# **LCS-1 Freedom Reduced Manning Study Report**

**AUGUST 2007**

This report describes the results of the first spiral of a study conducted by the NAVAIRWARCENWPNDIV Fire Science and Technology Office, to review the suitability of the Lockheed Martin Littoral Combat Ship (LCS-1 Freedom) design to obtain permission to operate helicopters with fewer personnel than required by the NAVAIR 00-80R-14 NATOPS U.S. Navy Aircraft Firefighting and Rescue Manual. The study, conducted from April through June 2006, included a survey of LCS ship personnel, a visit and inspection of LCS ship facilities, and preliminary LCS ship data and program review.

FIGURE 1. Starboard AFT AFFF Hose Reel Mounted High on Bulkhead.

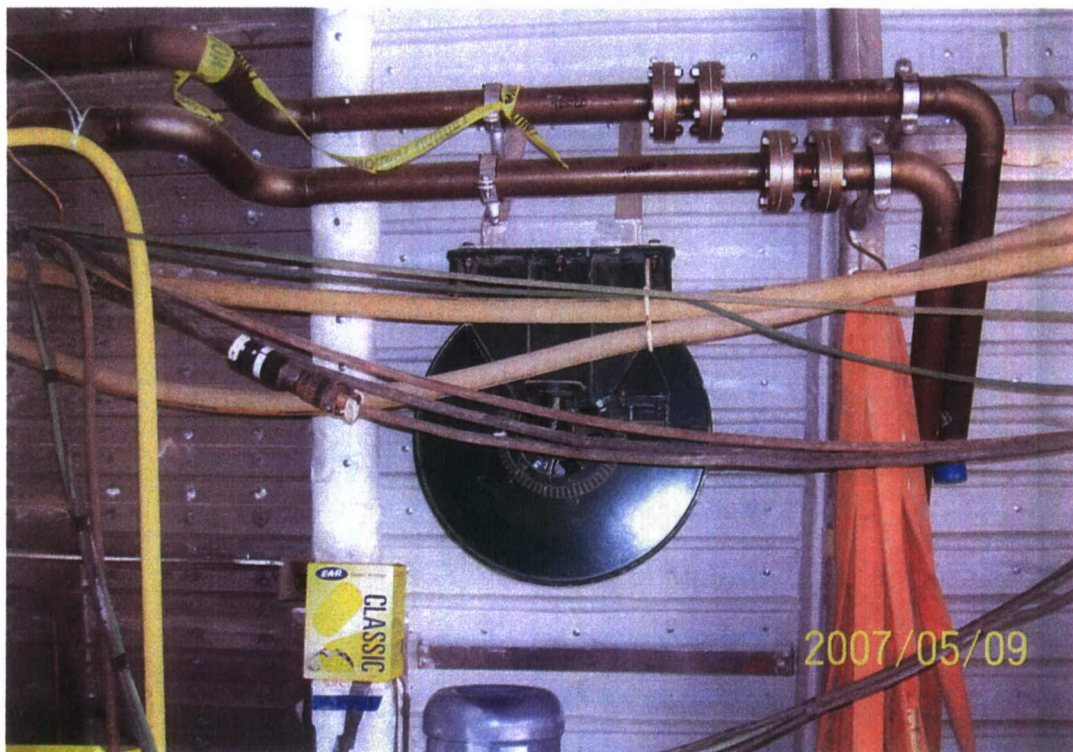
1. Starboard aft AFFF Hose Reel in Hangar: This hose reel is positioned high on the bulkhead with the Trigon control panel mounted between the hose reel and the flightdeck access door (Figures 1 and 2).

In this configuration it will be difficult for the hose team to pull heavy charged fire hose over the panel without hose couplings hanging up on and potentially damaging the Trigon System. There is also a three-inch diameter pipe in front of the hose reel that would impede direct feeding of hose off of the reel (Figure 3).

The proposed correction for this situation is to install hose roller guides on the framing between the hose reel and the door. These four sided roller guide assemblies would be similar to those mounted to the hose reel shown in Figure 5.

However, the proposed guide assemblies would only need to be large enough to fit a nozzle and thus could be smaller than that shown. The proposed guide assemblies would need to be designed such that they could be mounted cantilever off the frames in the subject area. This will permit the hose nozzle to be positioned at the door during flight operations. A single person will be able to immediately grab the nozzle as they exit the door and pull hose being fed off of the reel without the need to wait for a second person. Exact roller design and placement will be determined in collaboration with the LCS design team.

FIGURE 4. TRIGON Operating Console Obstructing Flight Deck Access Door.

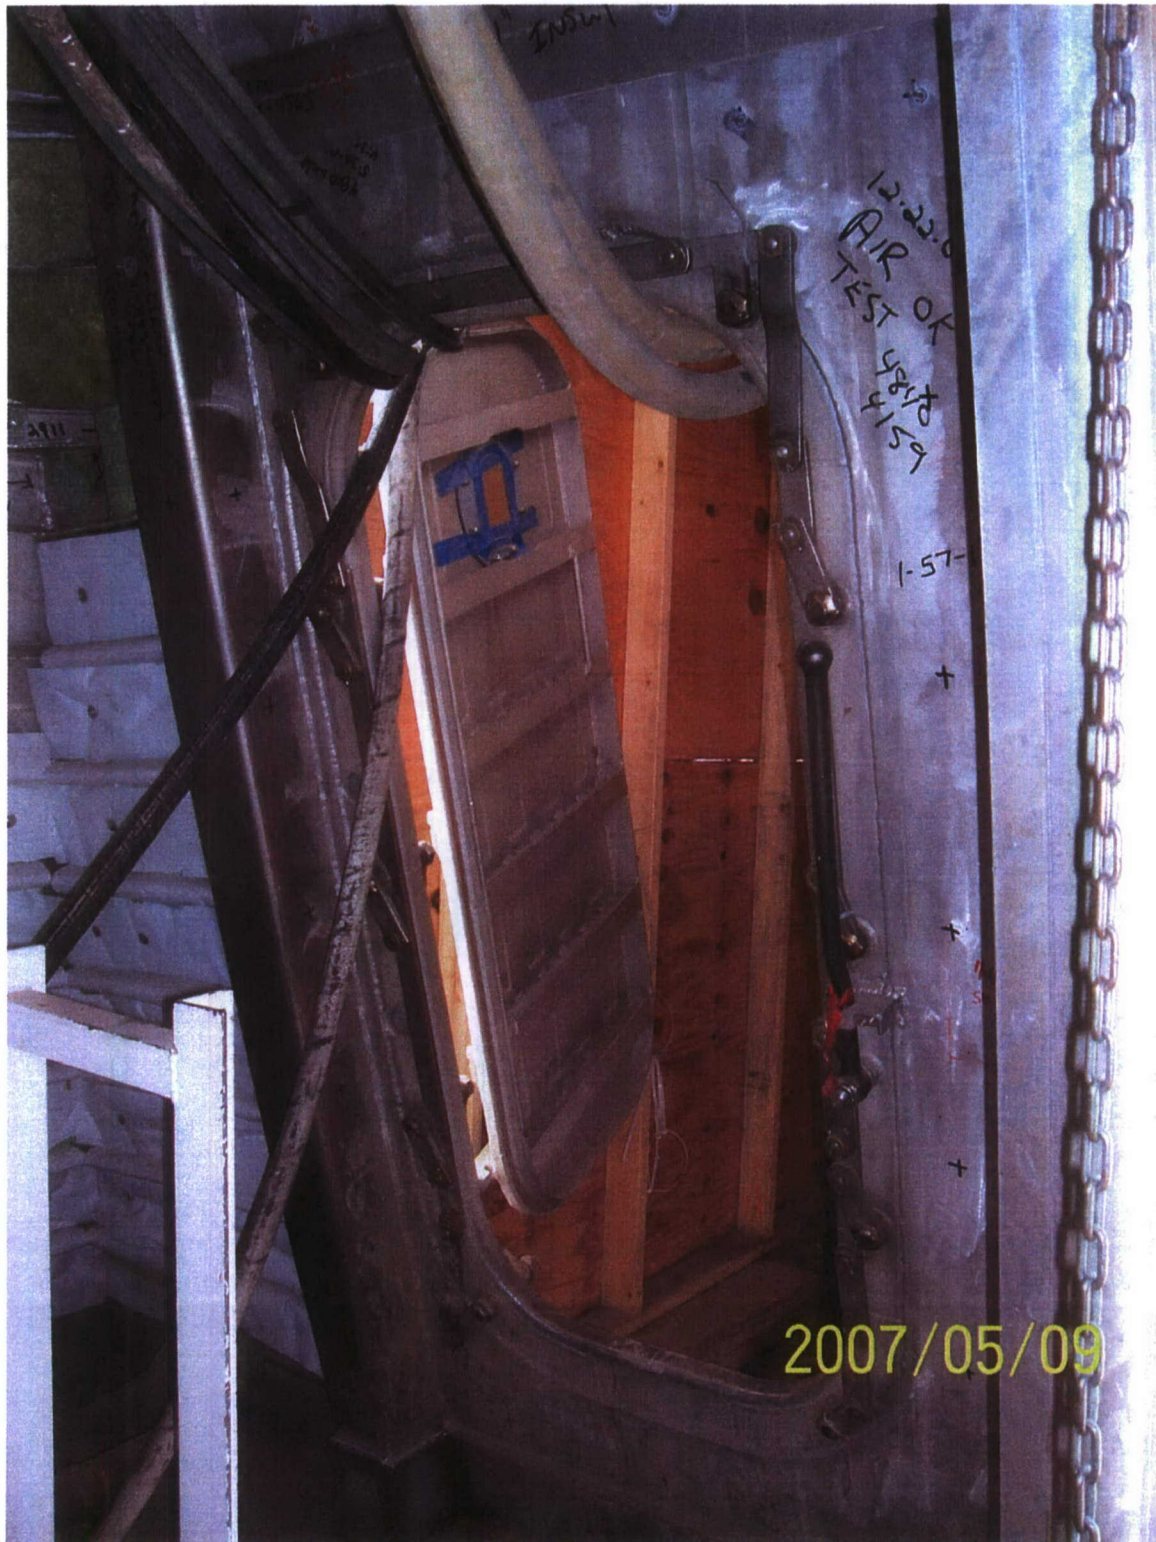
Flaking out hose on the hangar deck may help these situations, but would require hose to be played out in the primary personnel travel route from the interior of the ship to the flightdeck. The looping of the hose would also require one person to remain in the hangar as hose is being pulled to feed the hose through tight spots caused by the Trigon control panel which blocks full access through the door (Figure 4).

FIGURE 7. Port Flight Deck Access Vestibule Looking AFT. Note narrow walkway created by piping obstruction.

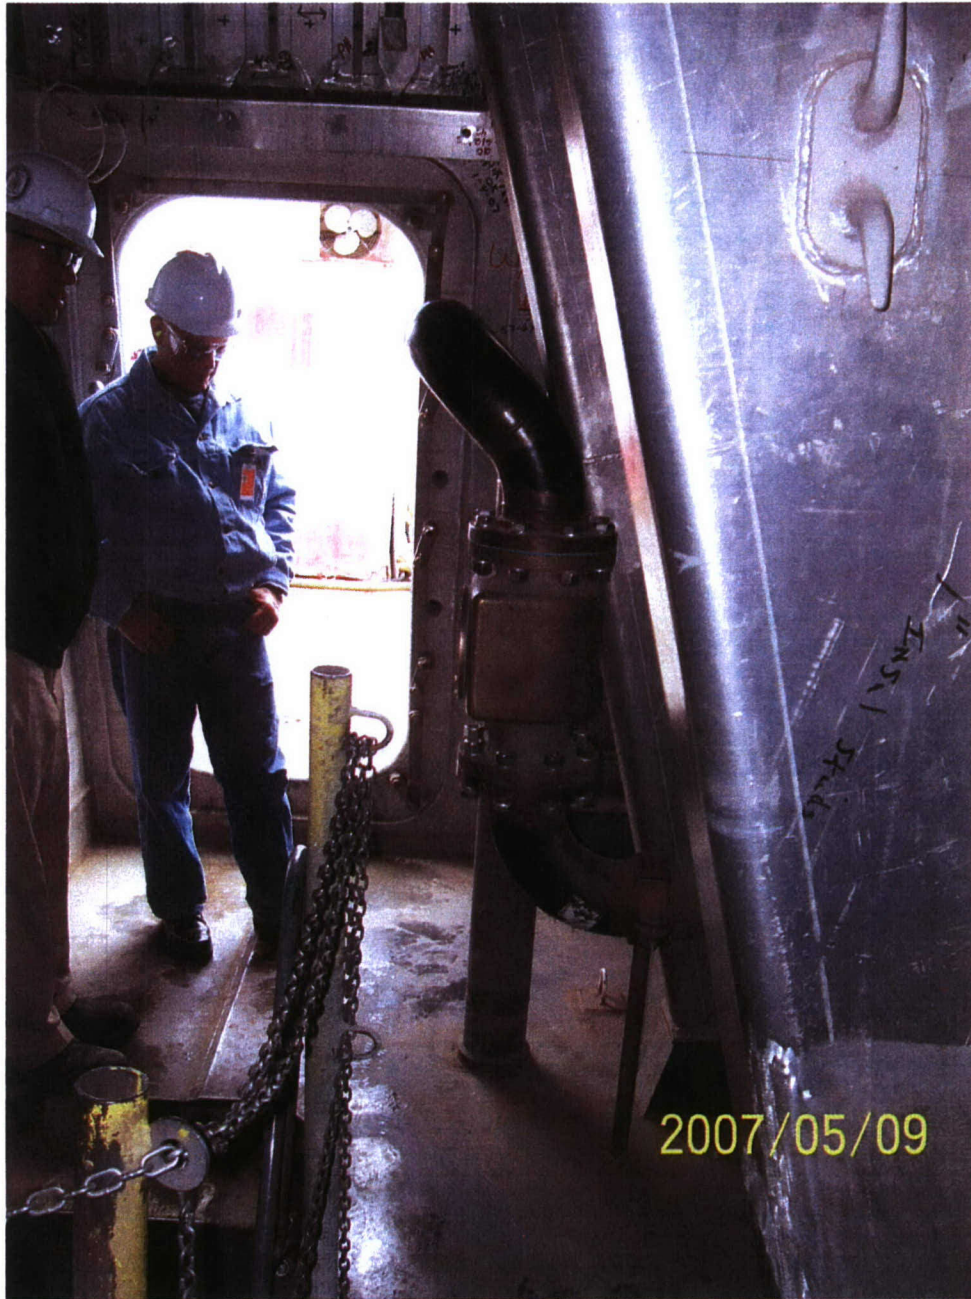
3. Port flight deck access vestibule: The fuel oil tank vent water vent/overflow plumbing is directly in the path of travel for firefighting teams from the hangar to the flight deck (Figures 7 and 8).

Traversing this path is difficult under normal conditions. With the added bulk of proximity suits with SCBA, while pulling hose, this path becomes a serious safety concern, due both to the difficulty of traversing this space without damaging fragile proximity suits as well as the hazard of falling into the adjacent ladder well while negotiating around bulkhead frames and plumbing installations

The proposed correction for this situation is to reposition vent piping close to the skin of the ship and out of way of vestibule traffic to open this path of travel to an acceptable width.

FIGURE 9. PORT AFT AFFF Hose Reel. Note payout is NOT in direction of flight deck.

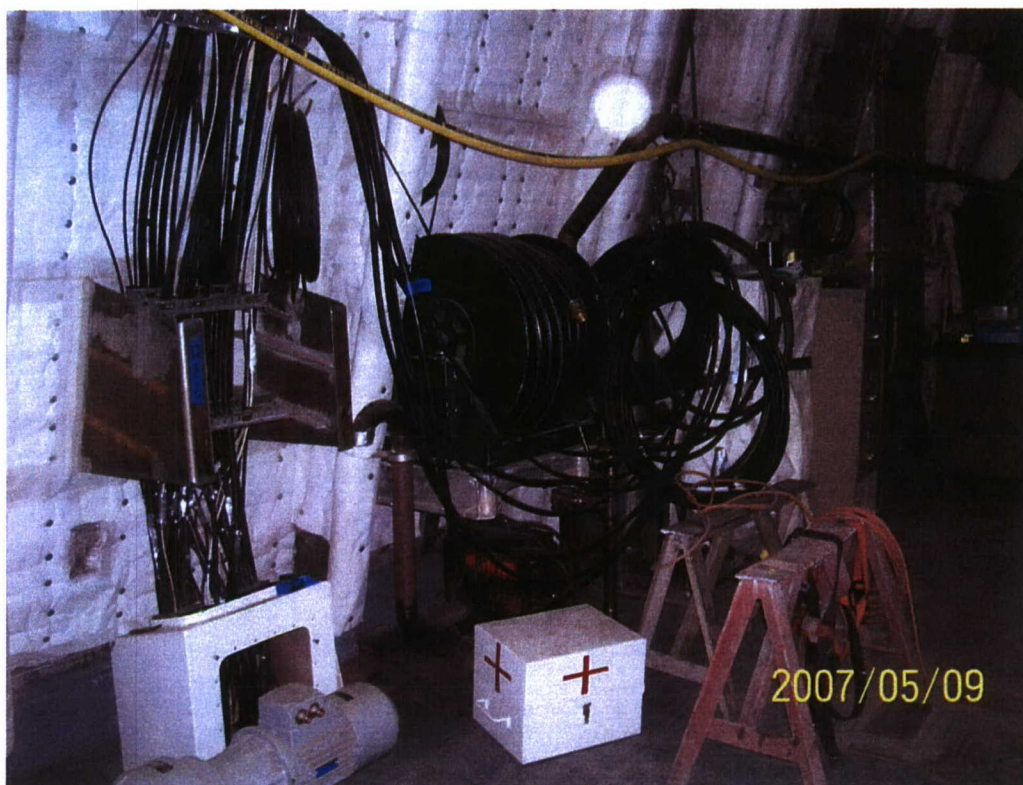
4. Port aft AFFF Hose Reel in Hangar: This hose reel is positioned low on the bulkhead with the barrel of the reel parallel to the port bulkhead, thus feeding hose inboard rather than aft toward the flight deck (Figure 9).

In this configuration it will be difficult for the hose team to pull heavy charged fire hose over at a right angle, requiring a minimum of two personnel and a slower response time to deploy the hose. Flaking out hose on the hangar deck may help this situation, but would require hose to be played out in a primary personnel travel route from the interior of the ship to the flight deck. This travel route is already narrowed due to the placement of Mission Module Containers. The looping of the hose would also require one person to remain in the hangar as hose is being pulled to feed the hose through tight spots caused by the mission containers, doorways and ladder from the first deck.

The proposed correction for this situation is to install the hose reel higher on the bulkhead and turned 90° so that hose feeds aft off of the reel similar to the installation of the aft starboard reel. Installation of hose roller guides on the framing between the hose reel and the exterior flight deck door will also eliminate the difficulties of pulling hose through the two doors and around the access trunk ladder. This will permit the hose nozzle to be positioned at the door during flight operations. A single person will be able to immediately grab the nozzle as they exit the door and pull hose being fed off of the reel without the need to wait for a second person. Exact reel placement and roller design and placement will be determined in collaboration with the LCS design team.

FIGURE 11. Area Between Ladder Well and Bulkhead is the Suggested Location for a Hose Tray in PORT Flight Deck Access Vestibule.

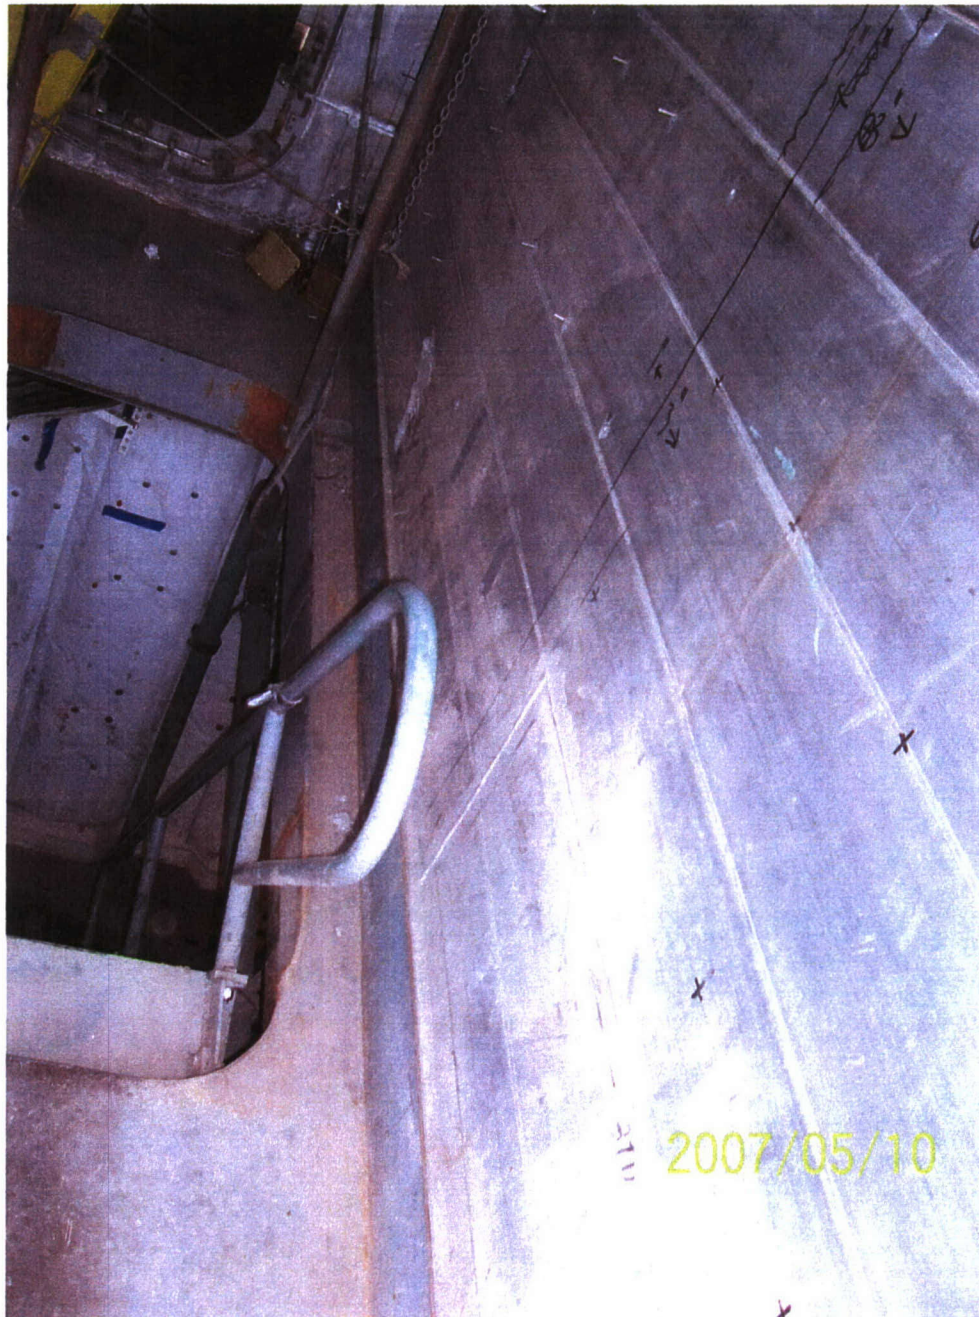
primary path of travel from the ship's interior to the flight deck. This travel route is already narrowed due to the placement of Mission Module Containers. Another problem with this location is that the hose connection port on the valve points forward, potentially causing a charged hose to kink against the Mission Module Container (Figure 10).

The proposed correction for this situation is to install in the vestibule in the gap between the bulkhead and starboard edge of the ladder well, a hose tray along the inboard bulkhead in the access trunk (Figure 11).

The hose would be connected as needed to the saltwater connection during flight operations and disconnected after flight operations have been suspended so that the door can be closed. This arrangement would permit one person to grab the hose nozzle and pull hose through the door feeding directly off of the tray. A structural fire apparatus hose fold can be utilized to assure proper playing out of hose off of the tray. The NAVAIR Fire Protection Team can provide guidance to the ships crew and to the training schools on this hose fold. Exact hose tray design and placement will be determined in collaboration with the LCS design team.

In order to correct the problem of kinked hose against the Container, the valve could be turned so that the hose connection port points toward the nearby starboard hatch.
